SULLIVANS SUBDIVISION

The purpose of this application is to subdivide three lots into four lots.

APPLICATION NUMBER 20 DATE June 3, 2004

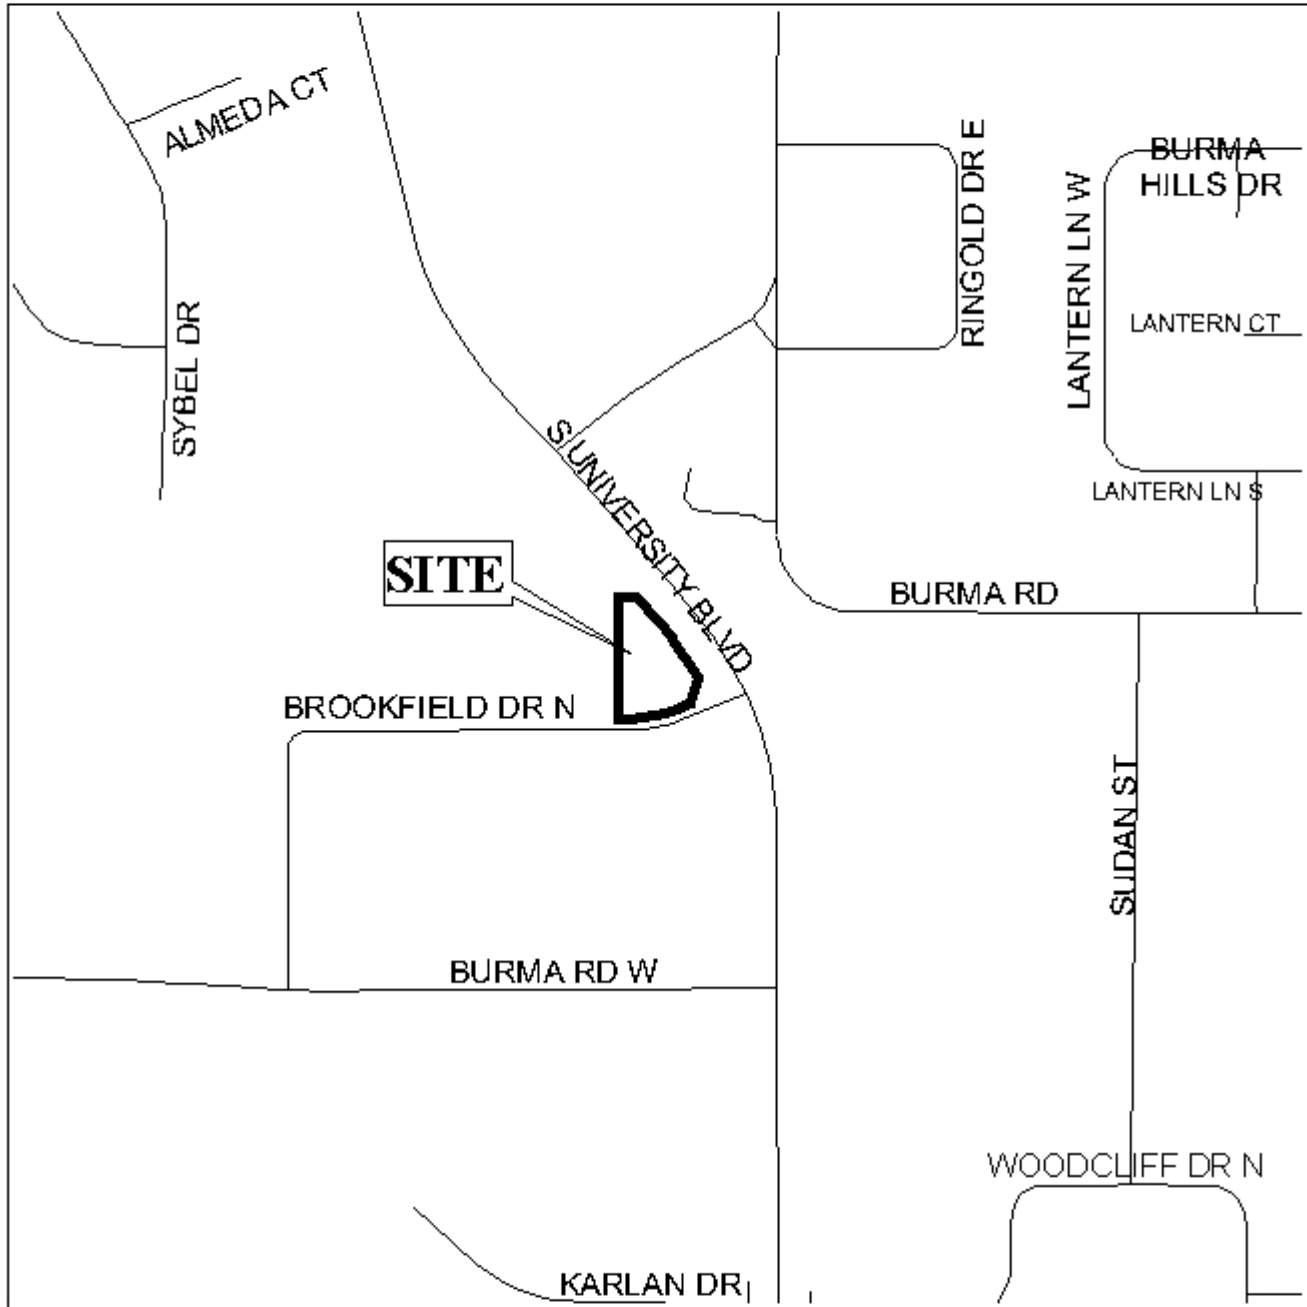
Engineering Comments: Must comply with all stormwater and flood control ordinances. Any work performed in the right-of-way will require a right-of-way permit.

Traffic Engineering Comments: Driveway numbers, size, location and design to be approved by Traffic Engineering and conform to AASHTO standards.

Urban Forestry Comments: Property to be developed in compliance with state and local laws that pertain to tree preservation and protection on both city and private properties (State Act 61-929 and City Code Chapters 57 and 64). As a reminder, any work on or under the 36" Live Oaks located on Lots 1 and 2 is to be permitted and coordinated with Urban Forestry.

Lots 3 and 4 front University Boulevard, a planned major street, and the existing right-of-way is shown as variable. The Major Street Plan requires a 100-foot right-of-way, therefore, the provision of a 75-foot setback from the centerline of University Boulevard, to provide for the right-of-way of the planned major street should be provided. This setback includes the required 25-foot minimum building setback line. Additionally, as a means of access management, a note should be placed on the final plat stating that Lots 3 and 4 are limited to one curb cut each to University Boulevard, with the size, location and design to be approved by Traffic Engineering. Also, Lot 1 should be denied direct access to University Boulevard.

The plat meets the minimum requirements of the Subdivision Regulations and is recommended for Tentative Approval subject to the following conditions: 1) the provision of a 75-foot setback (which includes the required minimum building setback of 25-feet) from the centerline of University Boulevard; 2) the placement of a note on the final plat stating that Lots 3 and 4 are limited to one curb cut each to University Boulevard, with the size, location and design to be approved by Traffic Engineering; 3) the placement of a note on the final plat stating that Lot 1 is denied direct access to University Boulevard; and 4) any work on or under the 36" Live Oaks located on Lots 1 and 2 is to be permitted and coordinated with Urban Forestry.
